Re: Recall No.: 00V-076

Technical BULLETIN

YZF-R1K, KC, L, LC; YZF-R6L, LC, M, MC FACTORY MODIFICATION CAMPAIGN

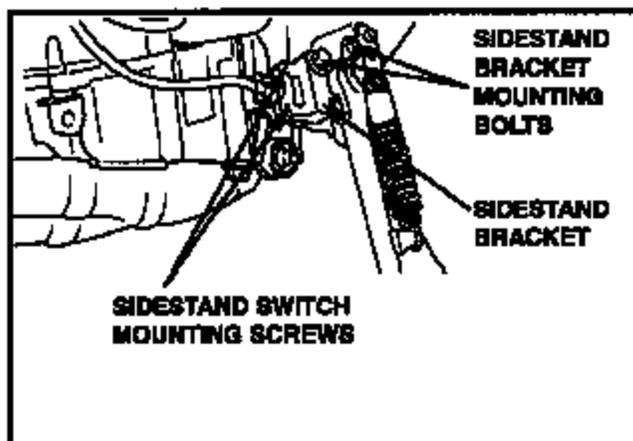
There was a mid-production change on 1999 YZF-R1 because a clamp was added to hold the fuel tank overflow hose and breather hose. The following motorcycles must be modified with Bolt Kit "B" which has longer bolts to accommodate the clamp on the switch:

All other affected YZF-R1 units as well as all affected YZF-R6 units use Bolt Kit "A."

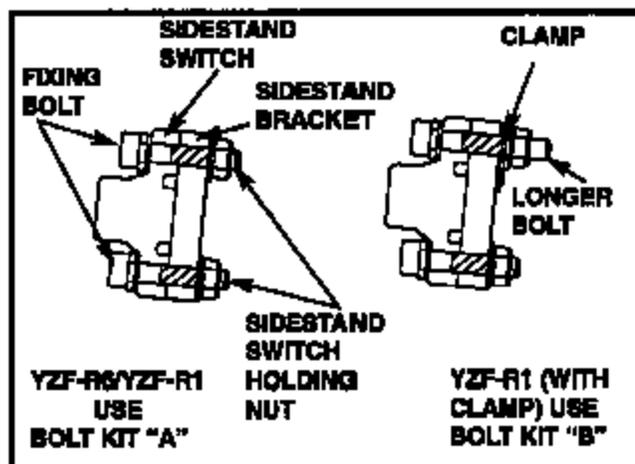
4. Assemble the sidestand switch again on sidestand bracket by installing the 2 new sidestand switch holding bolts from the kit.

Bolt Kit "B" is for YZF-R1 units with the clamp for hoses. Use the longer bolt in the top mounting hole where the clamp is located.

Tightening Torque: 3.8 Nm (0.38 m-k_g, 2.7 ft-lb.)

5. Hold the bolts to prevent rotation, then install the 2 sidestand switch holding nuts from the kit.

Tightening Torque: 3.8 Nm (0.38 m-k_g, 2.7 ft-lb.)
